*STP-209-1(2) Roadway and BHF-209-1(3) Bridge  
Widening of SR 74 From SR 85 to*

*P.I. Nos. 322355 and 322357*

**Value Engineering Study Report**

Preliminary Design Stage

ALTERNATIVE II  
 Sht. 2 of 8  
 ORIGINAL DESIGN

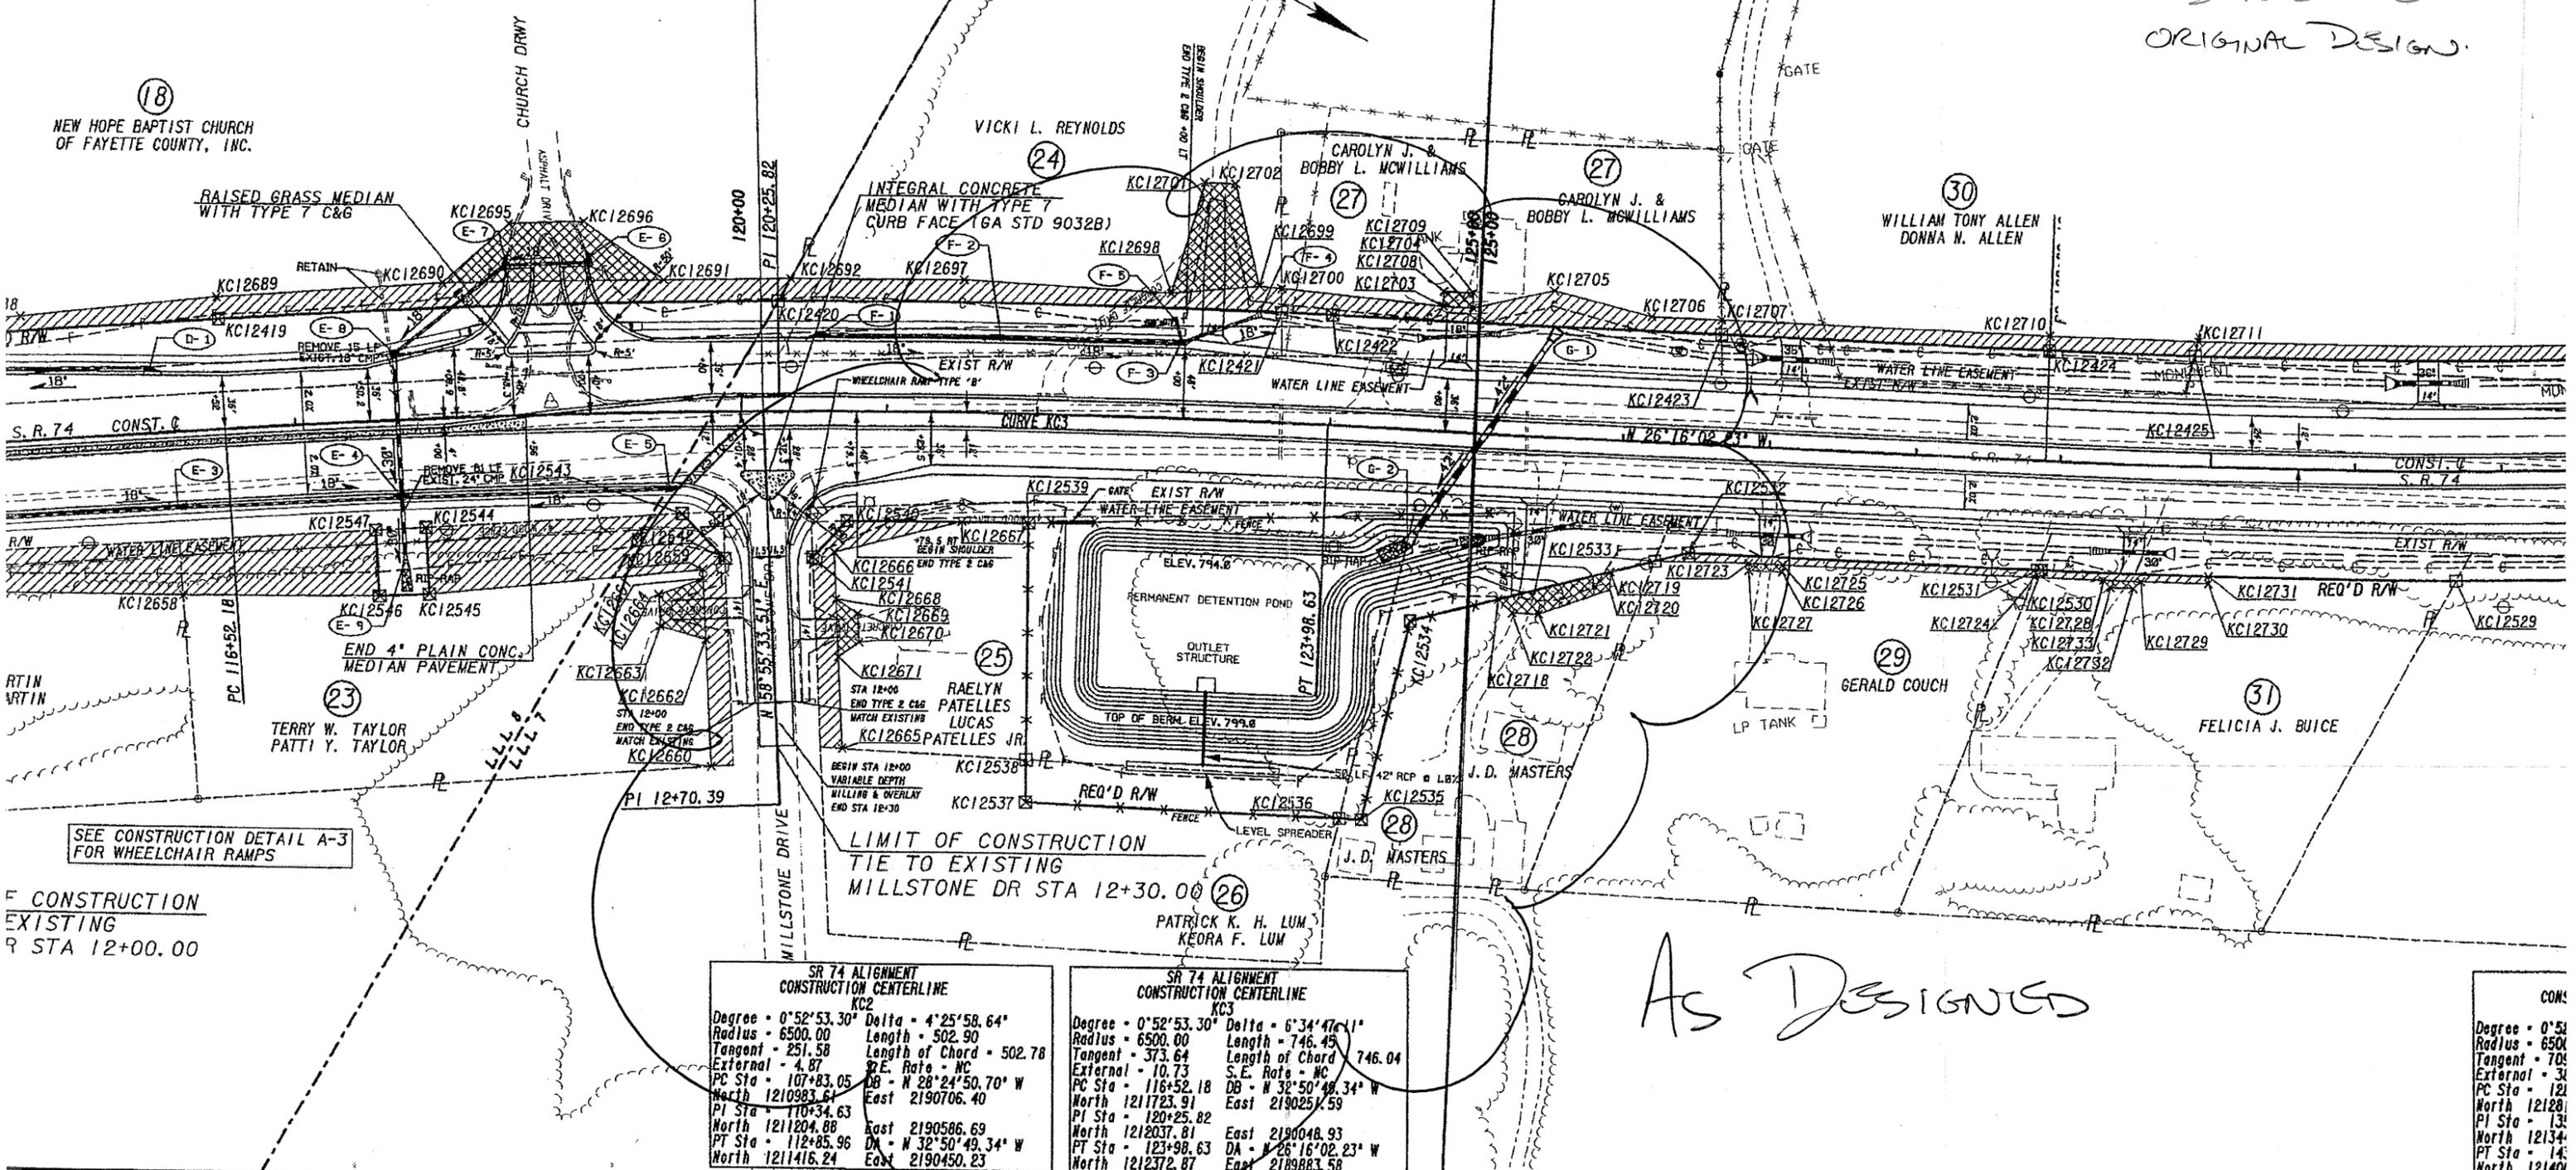
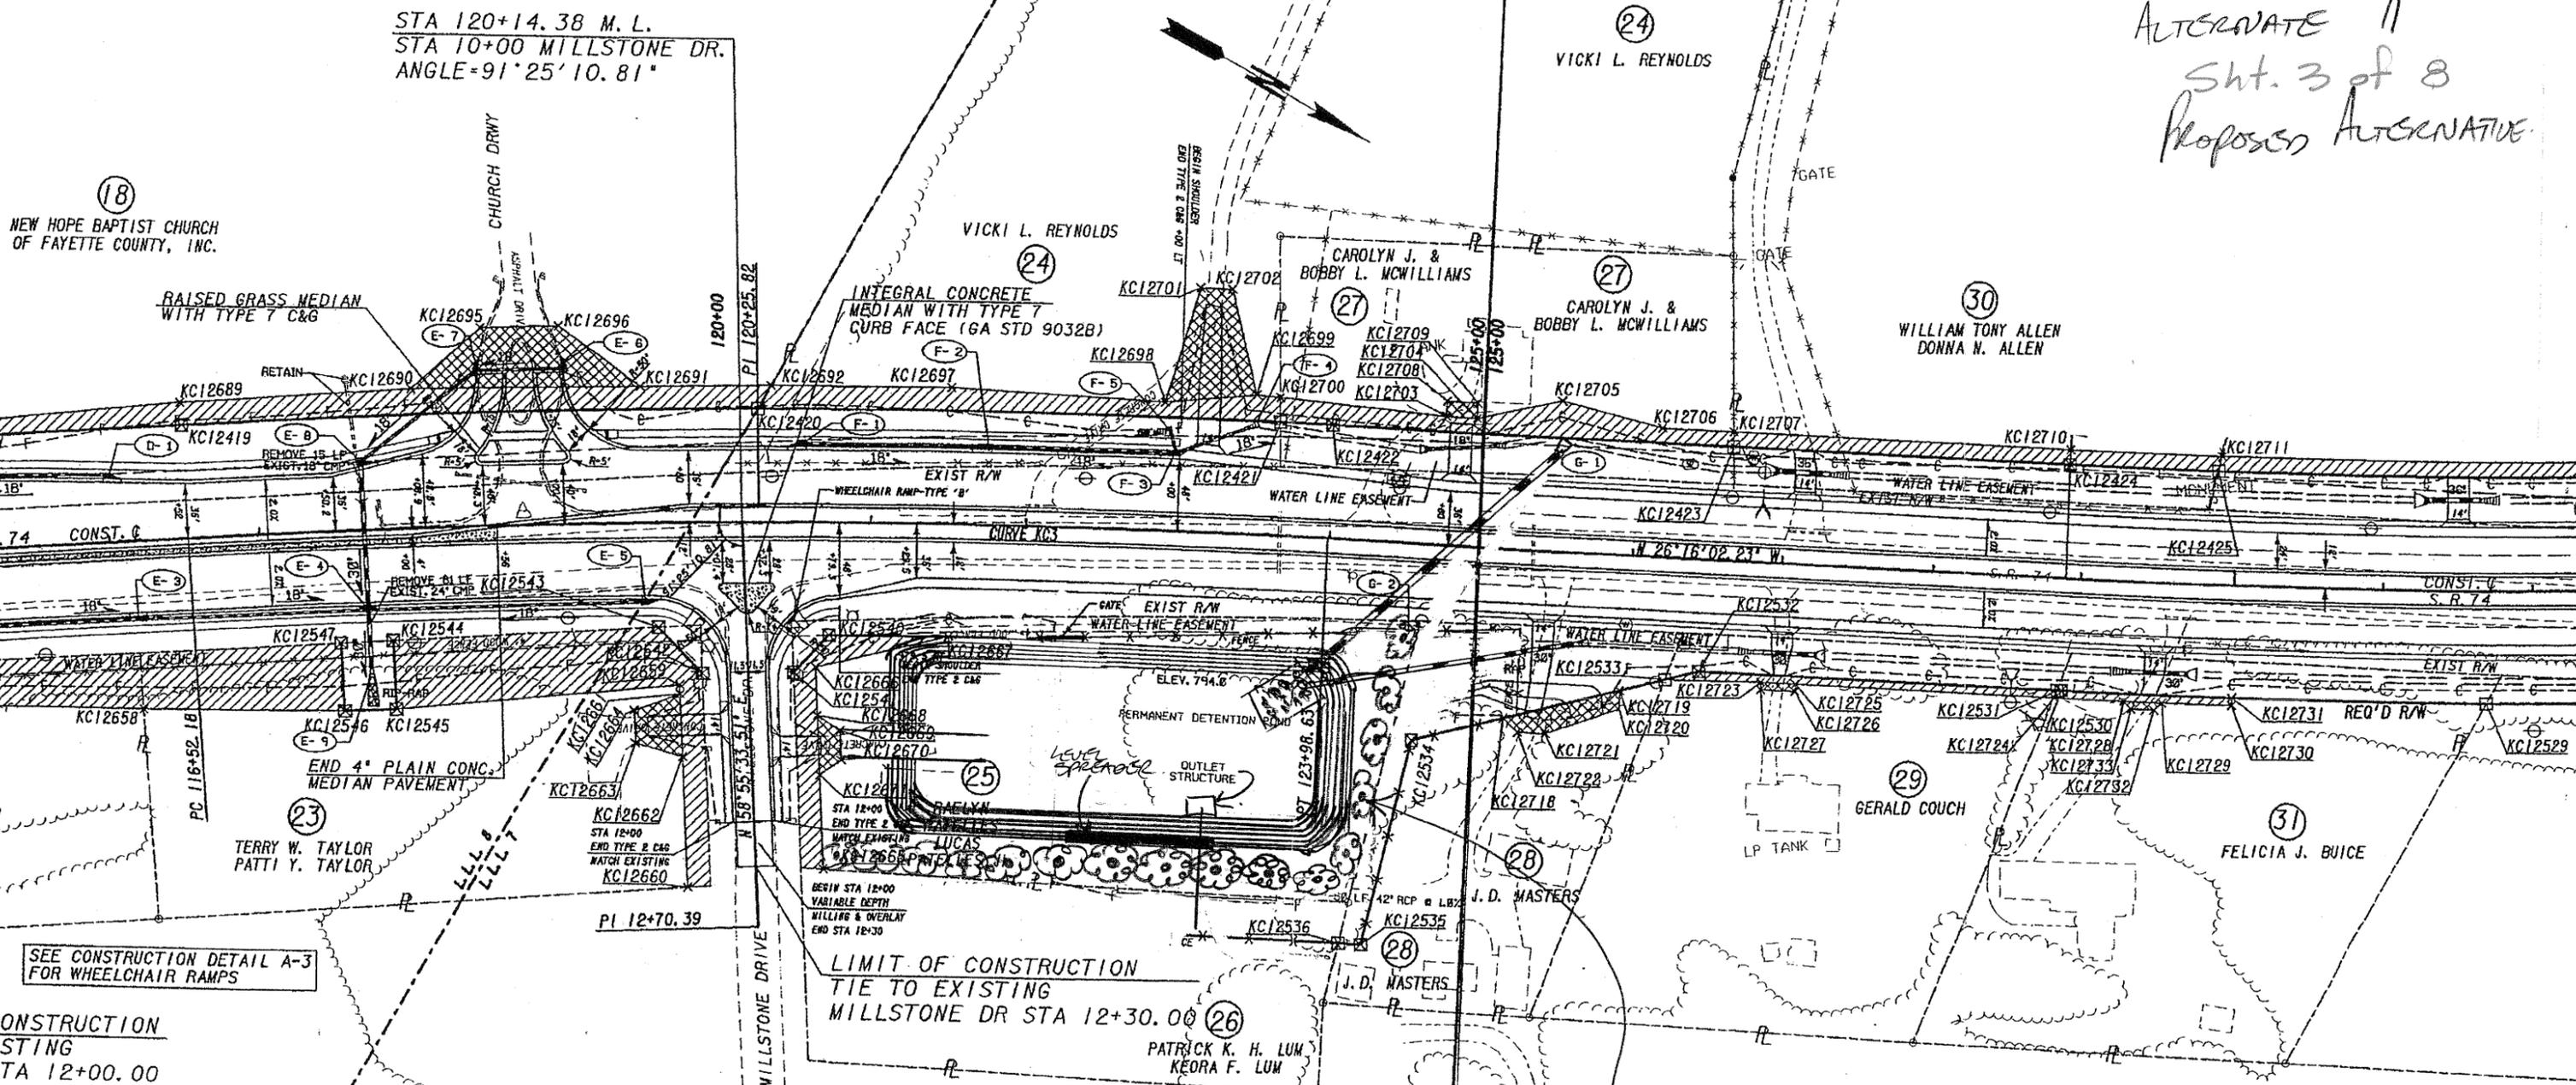
Contain the entire permanent detention basin within property #25. Adjust the drains to match the new location and place the trees along the property border as a visual screen. Provide access via the existing driveway to the property.

DESCRIPTION: **REDUCE THE LENGTH OF THE U TURN LANE AT LODGE TRAIL** SHEET NO.: **1 of 4**

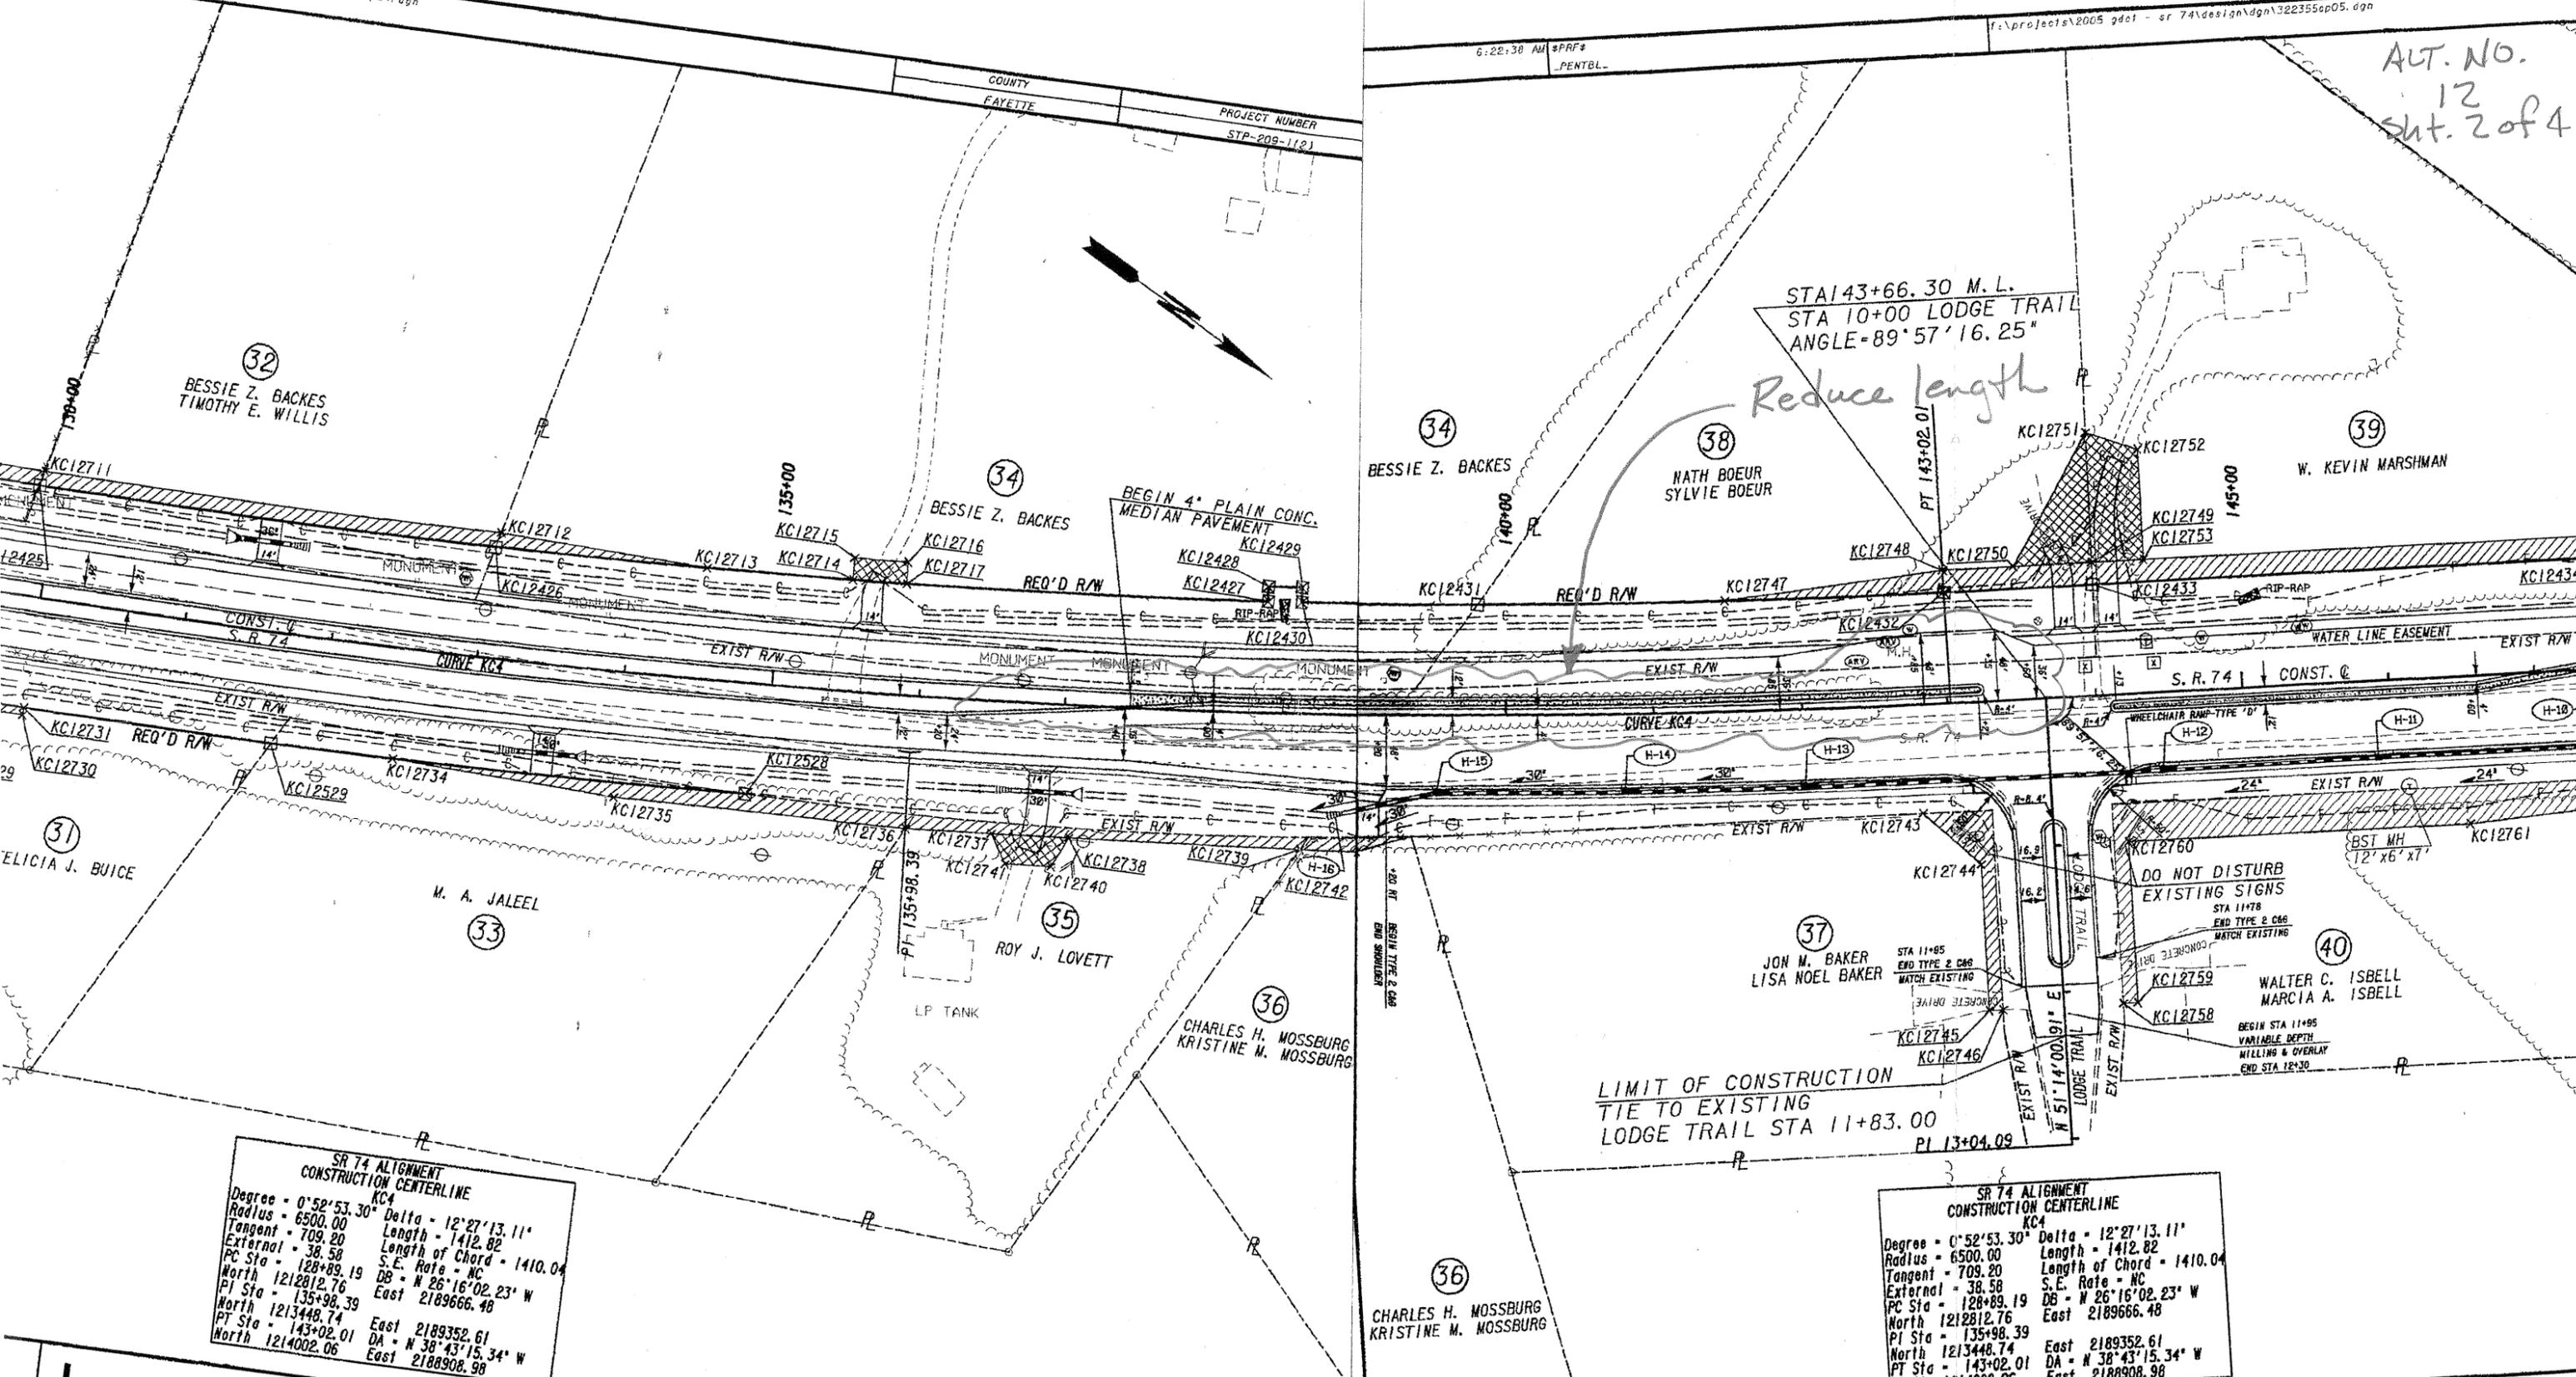
The long left turn lane provided at this intersection is unnecessary considering the projected traffic volumes.
